# SERVICE BULLETIN

SB1285

<b>ADDRESSEES</b>	: ABC Customer Care and Parts Source Owners and operators of coaches listed under 'Application'
<b>VEHICLE MODEL</b>	: CX45, TX40, TX45
<b>MANUAL SECTION</b>	: 10.62 Body and accessories - Seats
<b>BULLETIN TYPE</b>	: Field Change Program
<b>DATE</b>	: March 4th, 2016
<b>SUBJECT</b>	: <b>To check anchorage of passenger seats</b>
<b>TERMS &amp; CONDITIONS</b>	: Refer to the warranty section further in this Bulletin.

Figure 2: Proper fasteners to anchor passenger seats

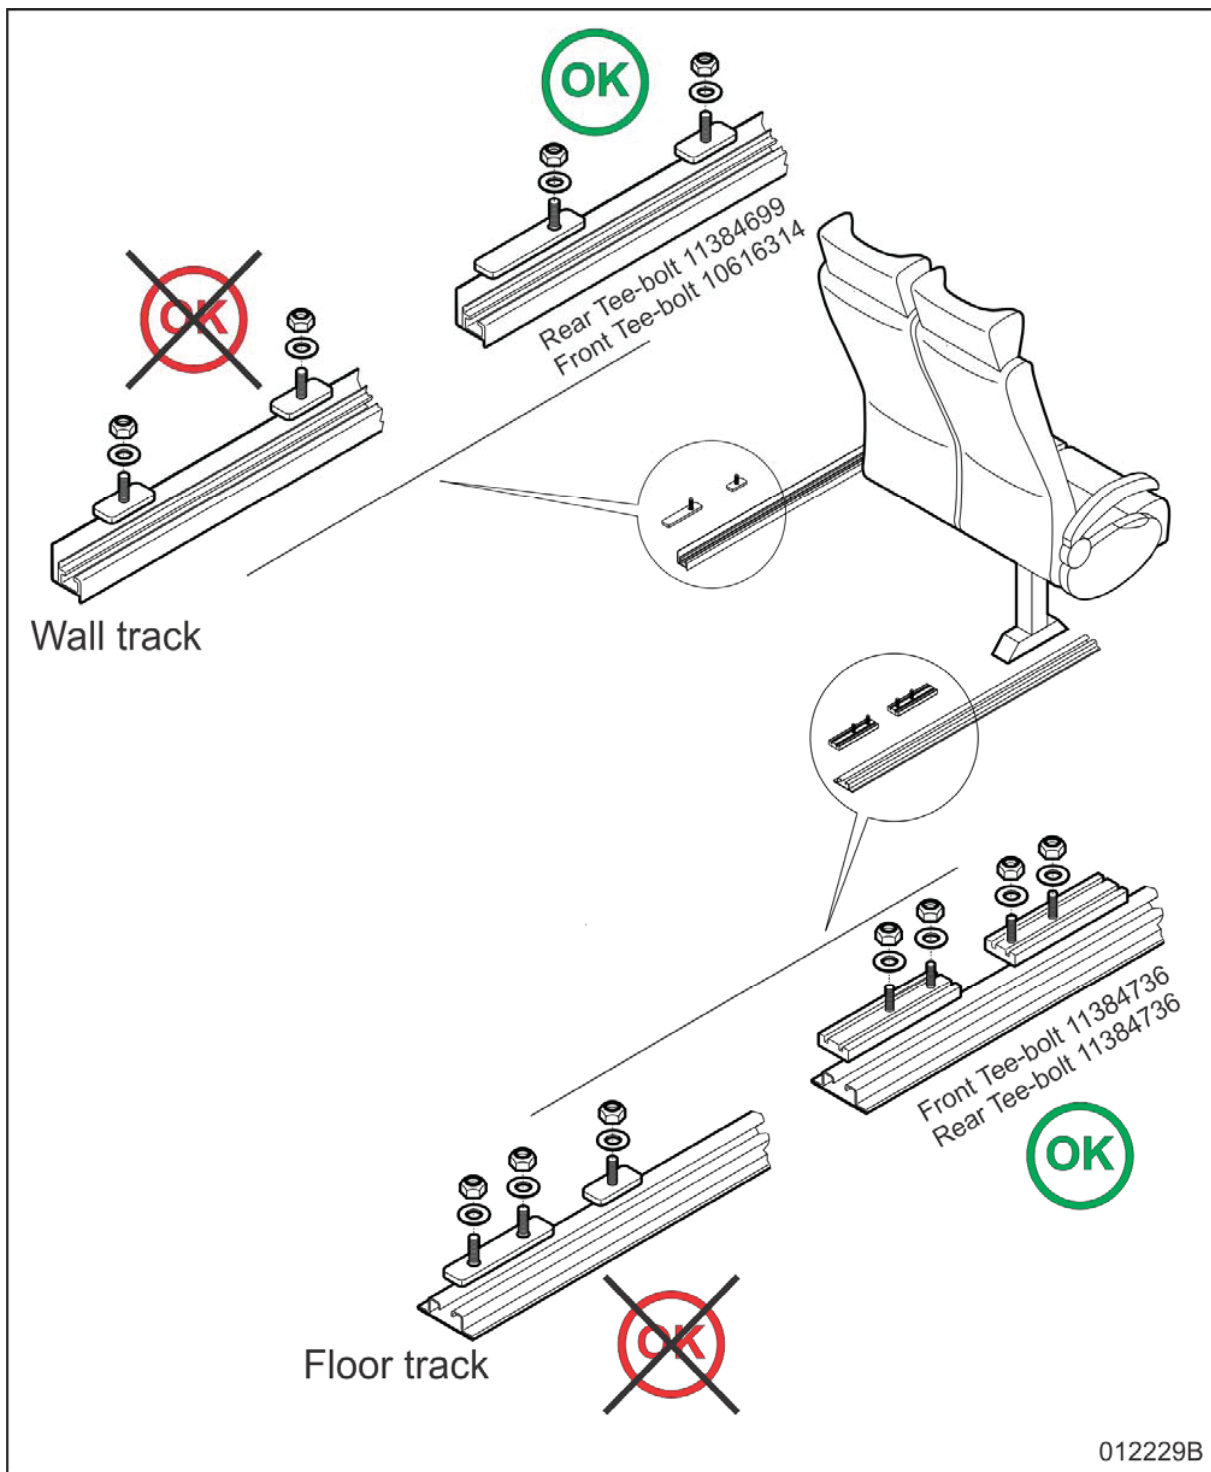
- On above mentioned vehicles it can be possible that too short Tee-bolts are used to secure the fixed seats.
- To address this issue, Van Hool is conducting a Field Change Program, the terms and conditions of which are explained further on under "Warranty".
- Owners and operators of the affected units should first check the anchorage of all passenger seats (except rear bench seats) and, if necessary, change the fastening system.

<b>Step</b>	<b>Action</b>
<b>1</b>	Check for the presence of the proper Tee-bolts (refer to figure 2).  Are the proper Tee-bolts installed? <ul style="list-style-type: none"><li>• If so, no further action required.</li><li>• If not, go to step 2.</li></ul>
<b>2</b>	Change the Tee-bolts. <ul style="list-style-type: none"><li>a. At the rear of the seat track in the floor, undo and remove the self-tapping screws securing the end cap to the floor. Remove the cap. Pry out the trim molding from the seat track in the floor.</li><li>b. Pry out the trim molding from the seat track in the sidewall.</li><li>c. Mark the position of the seats on the floor.</li><li>d. Undo and remove the locknuts and washers securing the seat to the floor track and sidewall track.</li><li>e. Put the seat assembly aside.</li><li>f. Do this for all seats at that side.</li><li>g. Slide all Tee-bolts out of the seat tracks.</li><li>h. Slide the proper Tee-bolts in the rails (refer to figure 2 for proper location and orientation of the Tee-bolts).</li><li>i. Reinstall the seat assemblies using new washers and locknuts. Tighten the Tee-bolt locknuts to a torque of 60 Nm (44 ft.lbf).</li><li>j. Install the trim molding into the seat tracks using a soft-faced mallet.</li></ul>
